Addendum: **2**

Date: **5/13/2025**

Project: **FWCS HPB Natatorium HVAC Improvements**

Comm #: **24634**

SHEET:

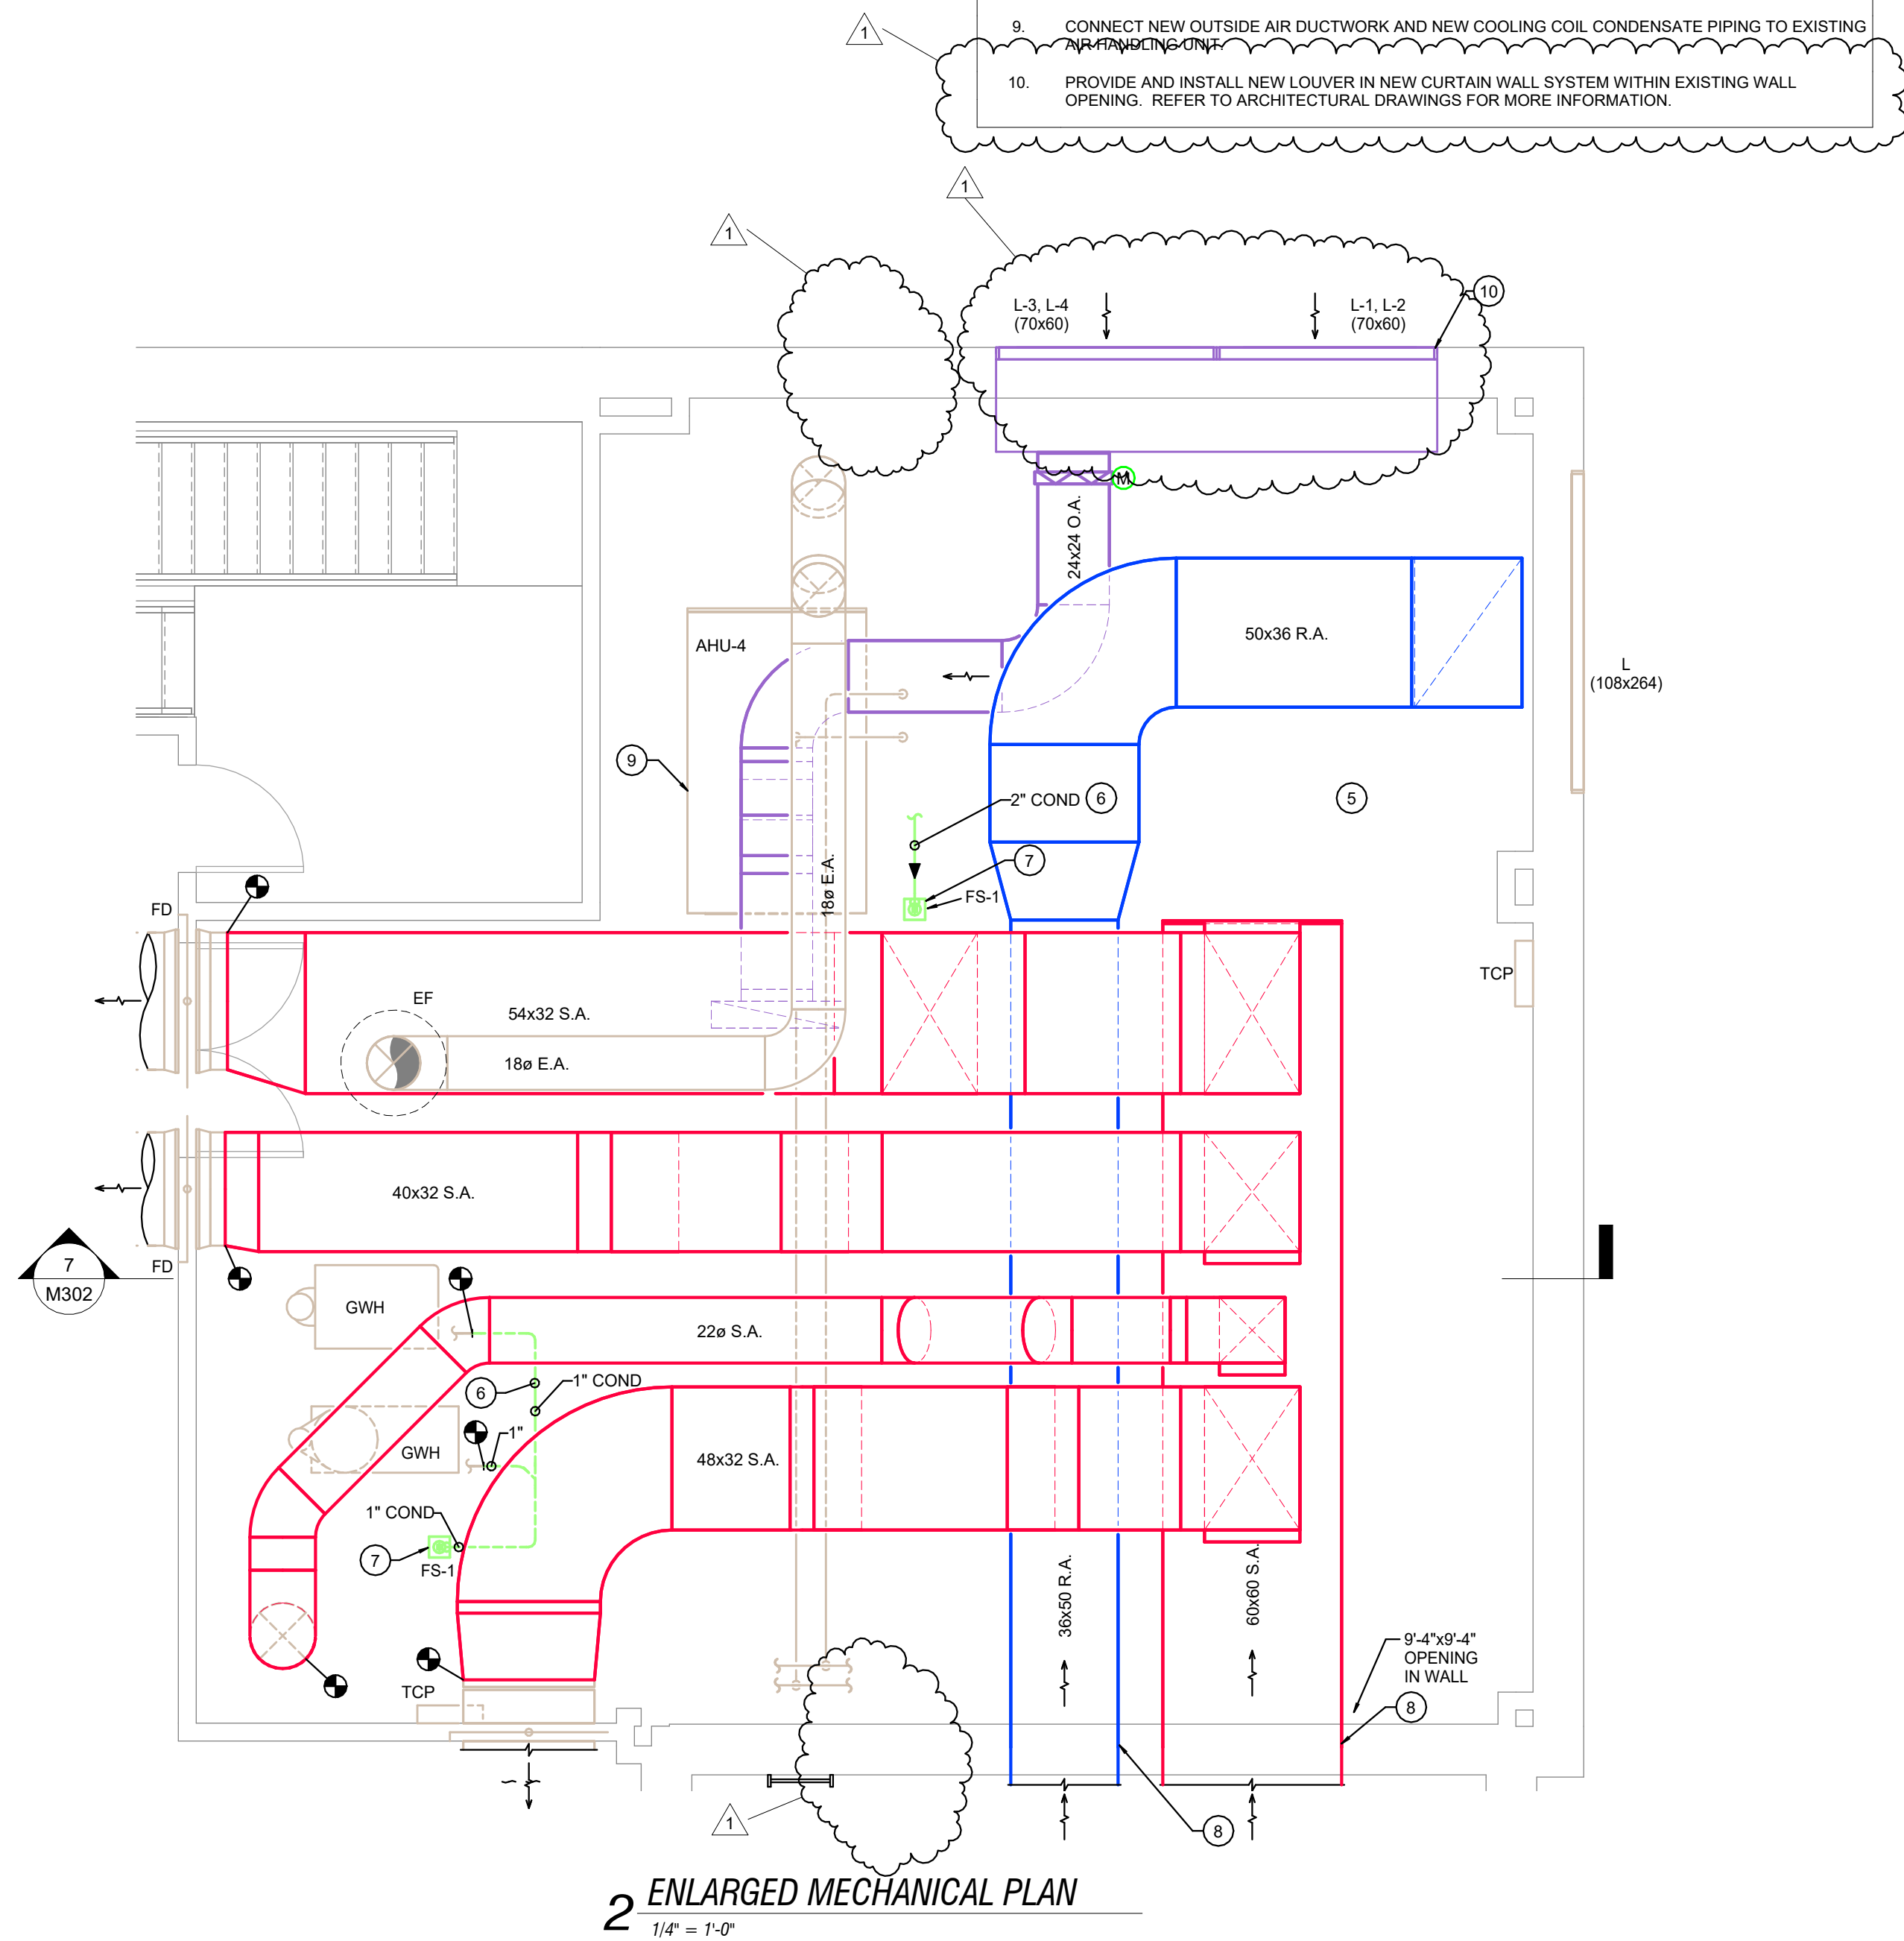
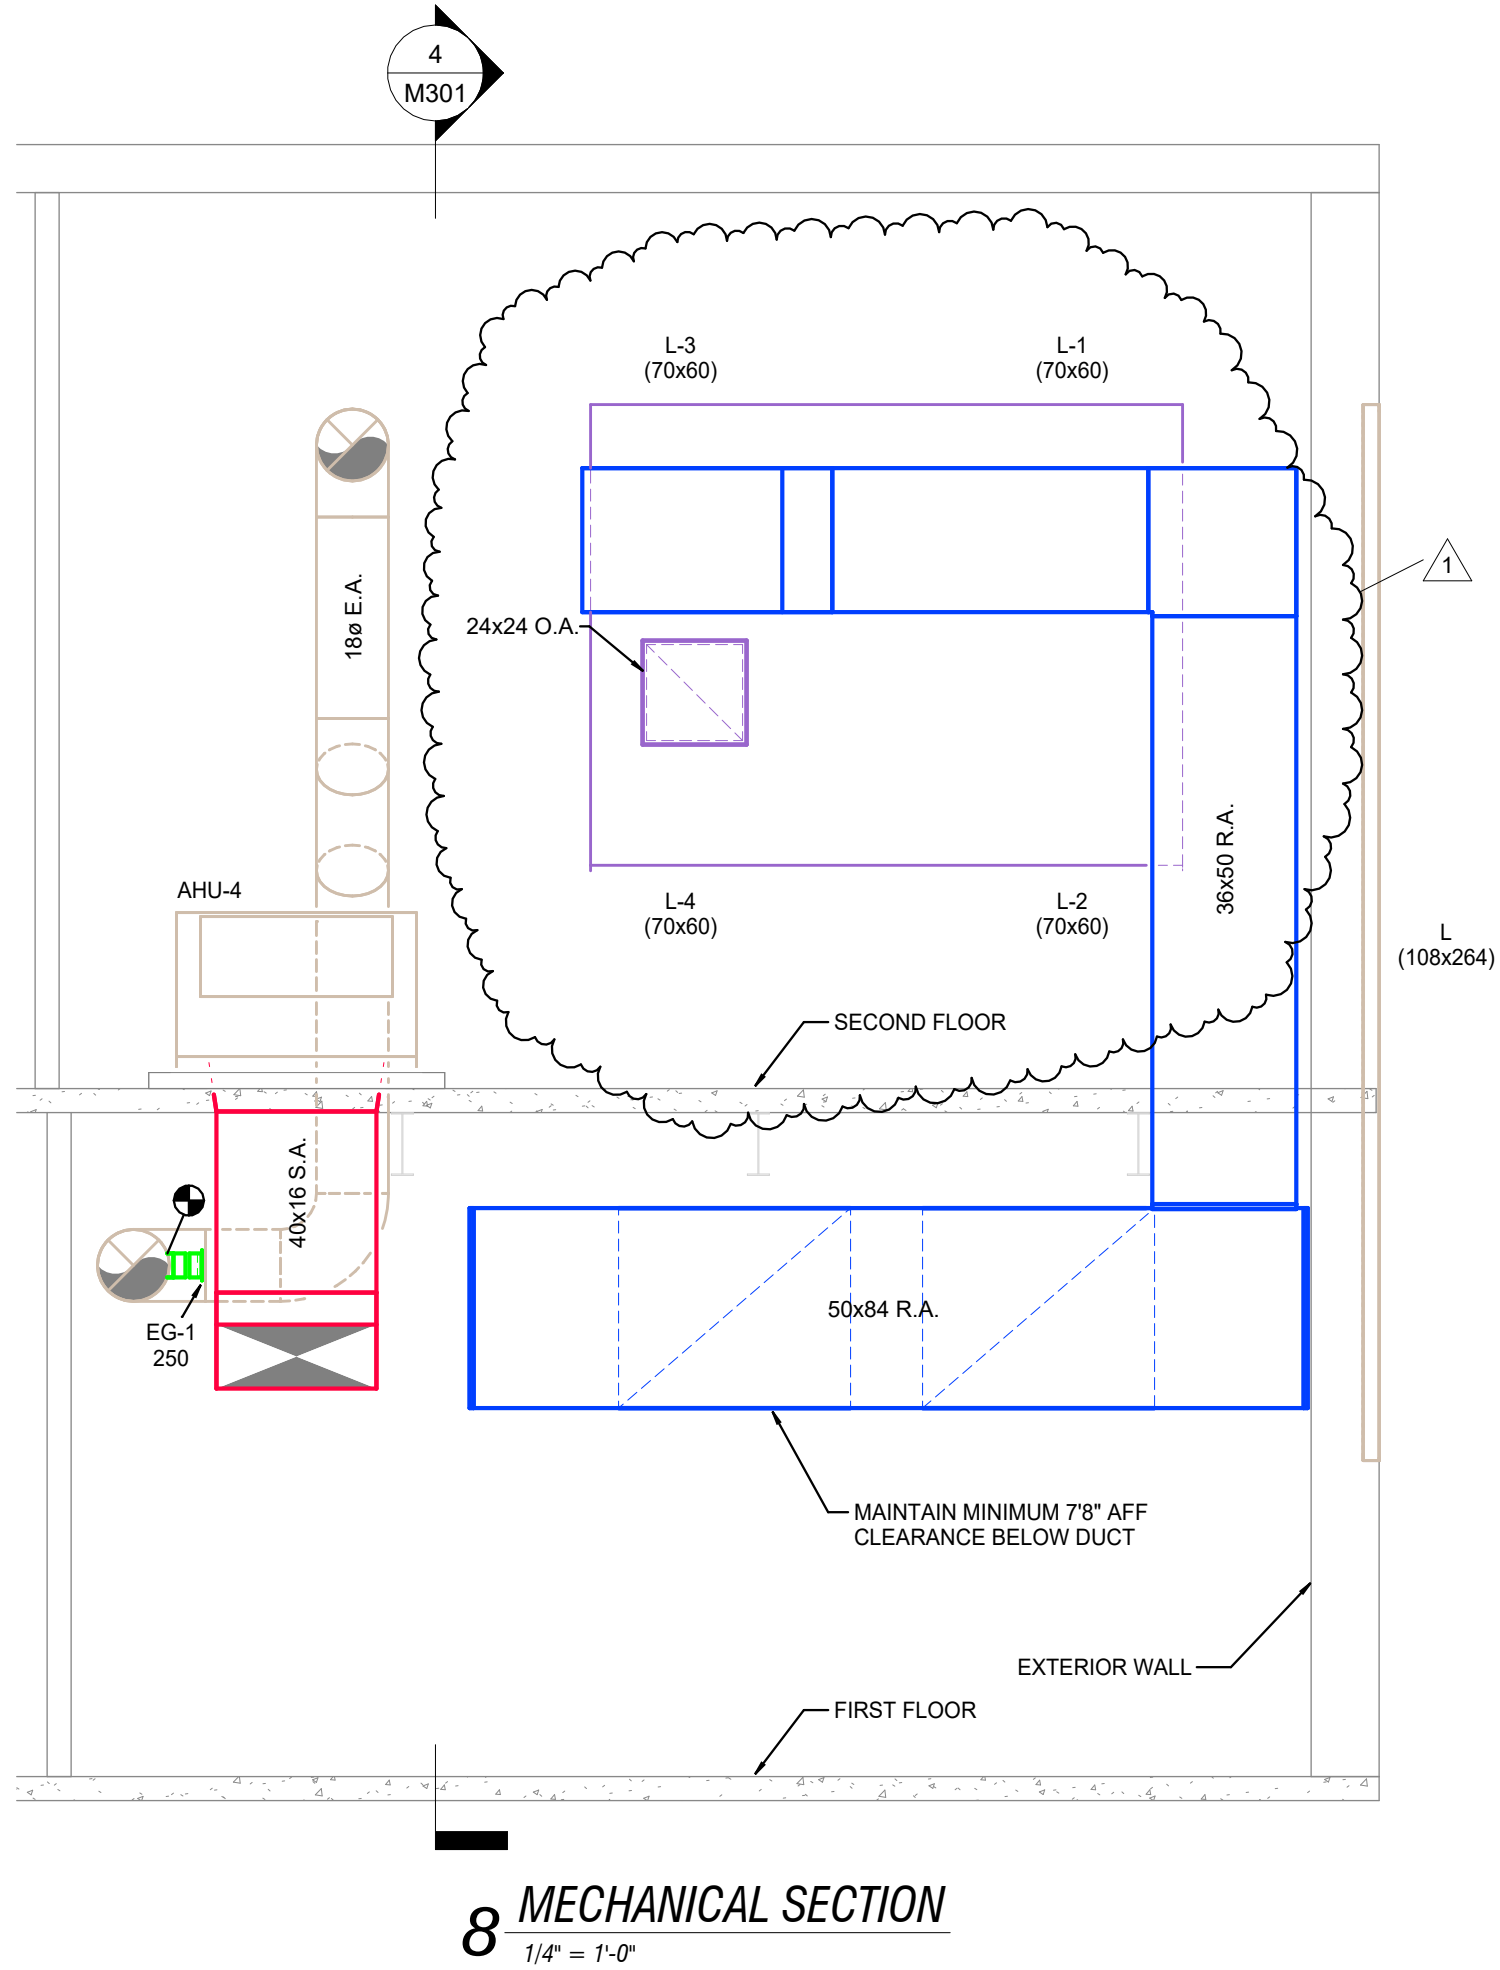
- A.** Revise louvers L-1 and L-2 to be louvers L-1, L-2, L-3, and L-4. Refer to attached drawing revision dated 5/13/2025.

Item #6: Drawing Sheet M302, "Enlarged Mechanical Plan and Sections."

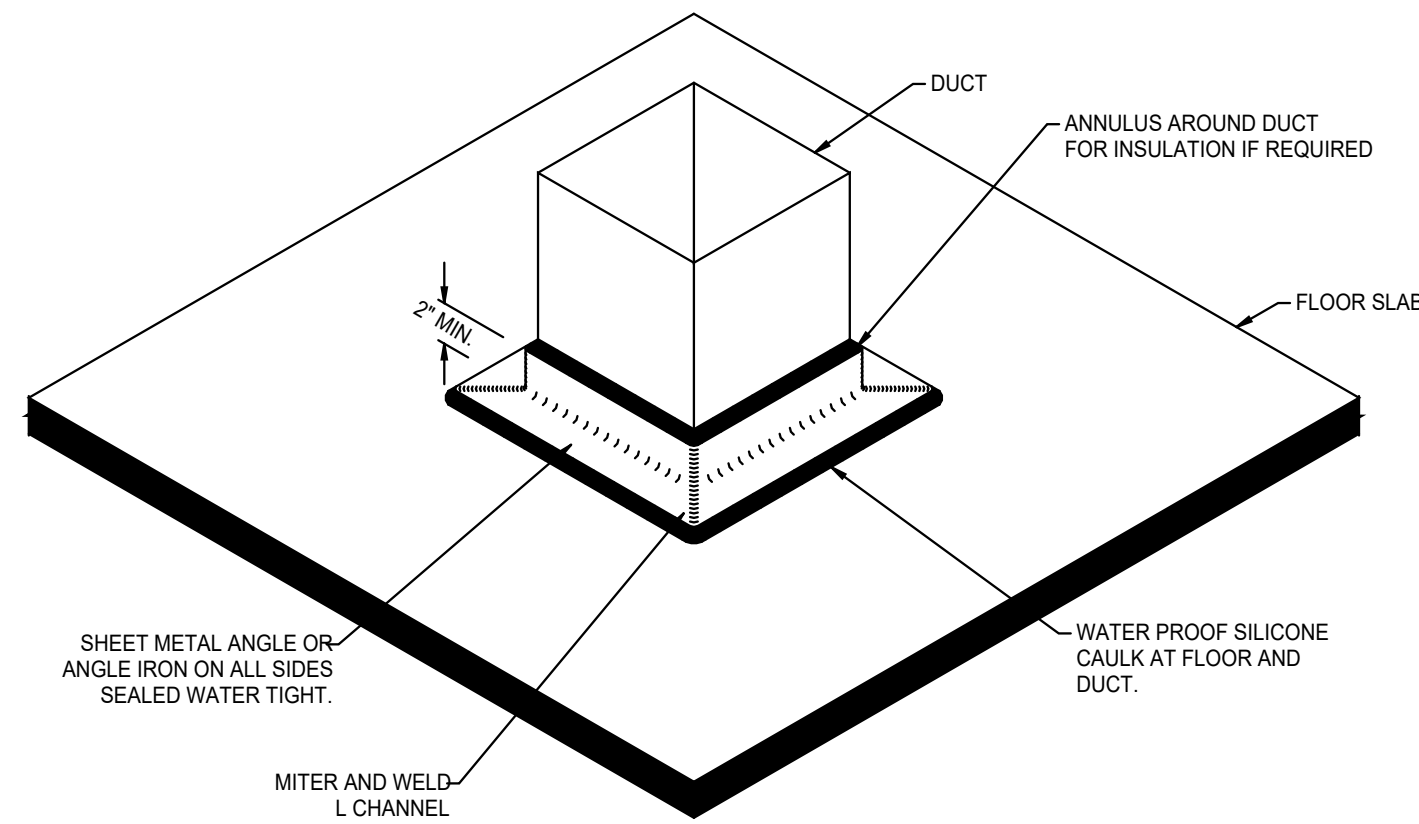
- A.** Revise louvers L-1 and L-2 to be louvers L-1, L-2, L-3, and L-4. Revise Plan Note #10. Remove section view reference. Refer to attached drawing revision dated 5/13/2025.

AHU-1 DETAIL

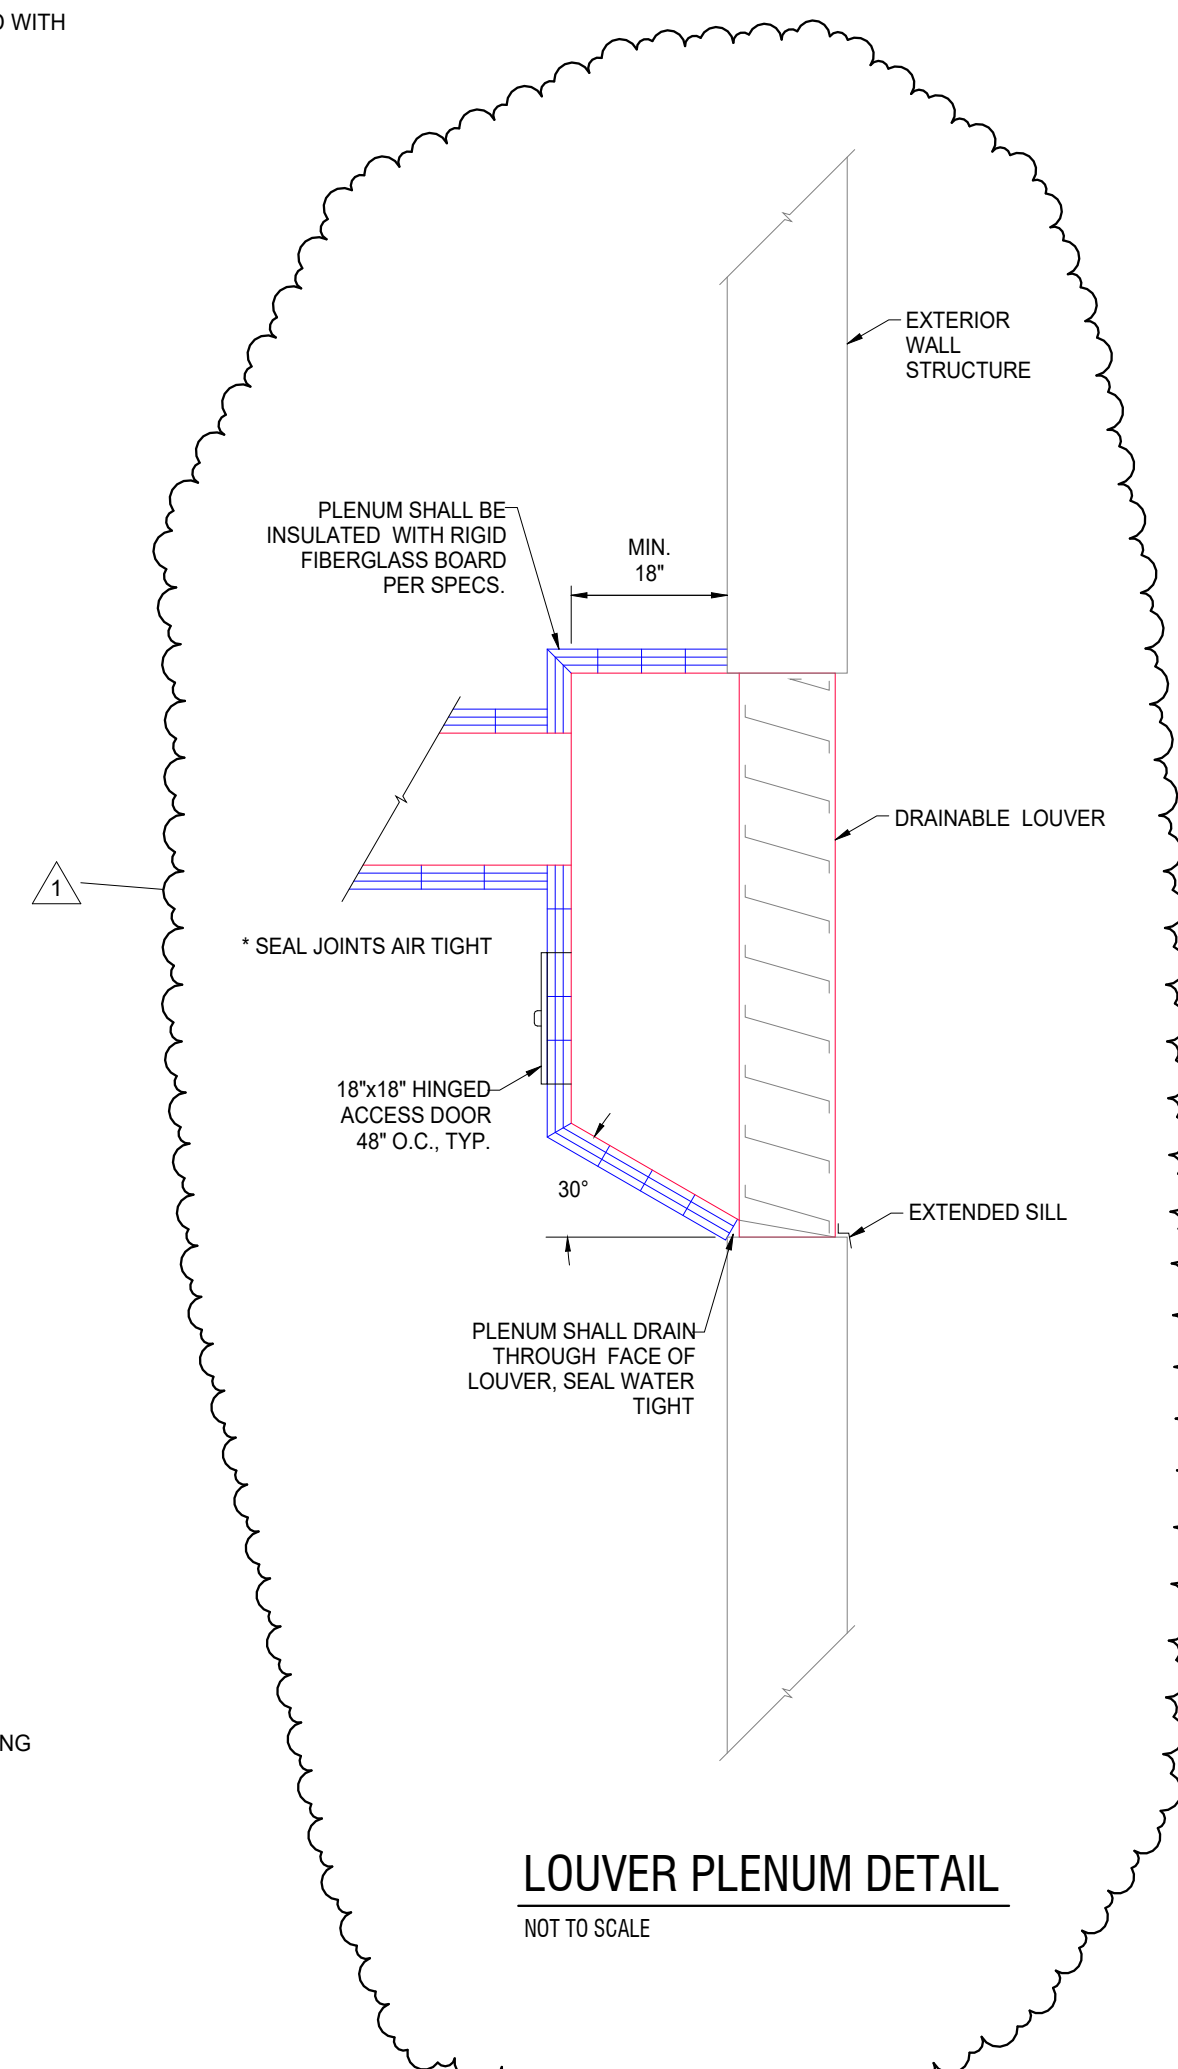
- A.** Add Louver Plenum Detail. Revise AHU-1 Detail. Refer to attached drawing revision dated 5/13/2025.
